ADMINISTRATIVE AMENDMENT

MESA DEL SOL REGIONAL RECREATION COMPLEX

**ADMINISTRATIVE AMENDMENT • SITE PLAN
LOCKER ROOM FACILITY AT MDS**

LOCKER ROOM FACILITY AT MDS
Albuquerque, New Mexico

PHASE 1B AMPHITHEATER OVERALL PLAN SHEET 1 OF 14

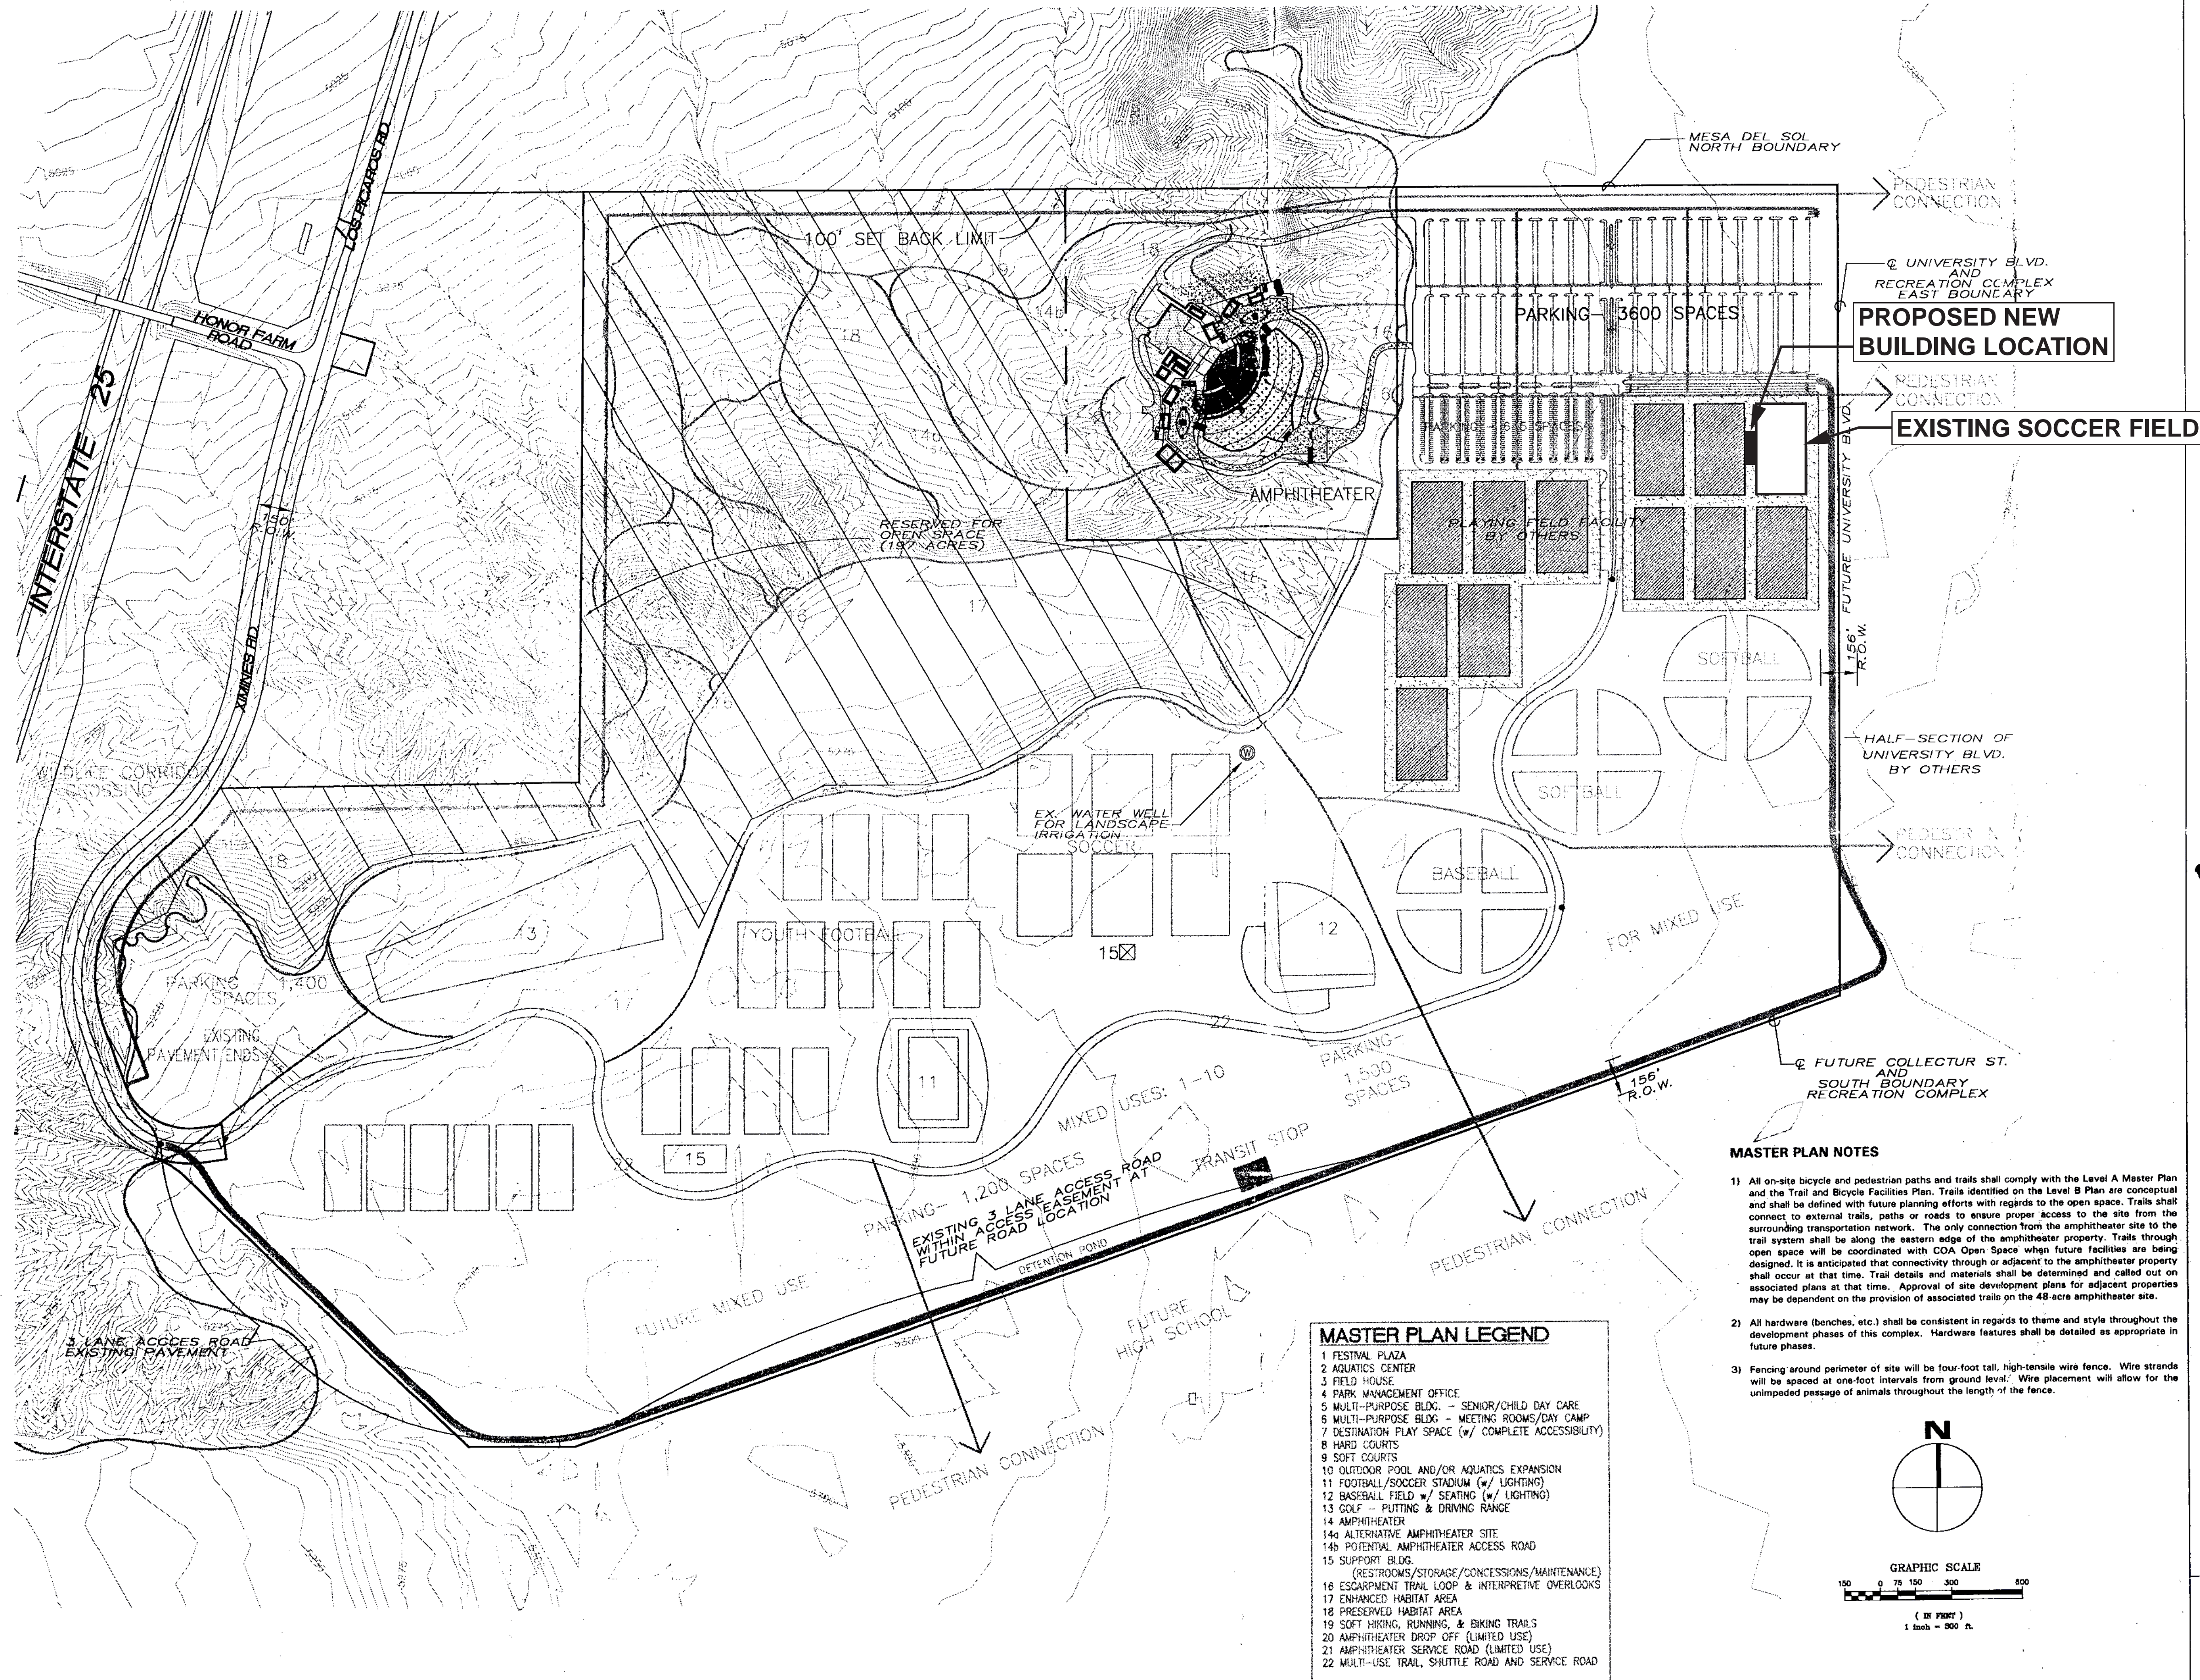
AMPHITHEATER AND ASSOCIATED FACILITIES INCLUDING STORAGE FACILITIES, RESTROOMS, TICKET SALES OFFICE AND CONCESSIONS. THE AMPHITHEATER ACCOMMODATES A MAXIMUM OF 12,000 SPECTATORS PURSUANT TO THE MESA DEL SOL LEVEL B PLAN, TRAFFIC IMPACT STUDY APPROVED MAY 25, 1998. SUPPLEMENTAL TRAFFIC ANALYSIS DATED JUNE, 2000, AND THAT PERFORMANCE WILL BE CONTROLLED EVENTS WITH APPROVED TRAFFIC MANAGEMENT. CAPACITY TO EXPAND TO 15,000 ONCE ACCESS IS PROVIDED FROM UNIVERSITY BOULEVARD.

PREVIOUSLY APPROVED SITE PLAN • MODIFIED PER THIS ADMINISTRATIVE AMENDMENT • LOCKER ROOM FACILITY AT MDS
